Access Compliance Report Public Rights-of-Way (Curb Ramps)

Intersection ID: 2491 Main Street: LYNNEWOOD GLEN DR **Cross Street: MCCHESNEY DR** Location: **Overall Compliance: No ADA ID: 6EB5E6DAE134** Ramp Type: PerpDiag Initial Pass/Fail: Fail Severity Score: 13.75

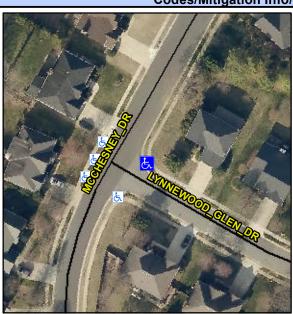
MCCHESNEY DR None LYNNEWOOD GLEN DR StopSign Possible Solutions: Remove & Replace Curb Ramp With Two New Directional Ramps or Equivalent. Surveyor Notes: N/A PROW/ADA: R304.2.2, R304.5.3
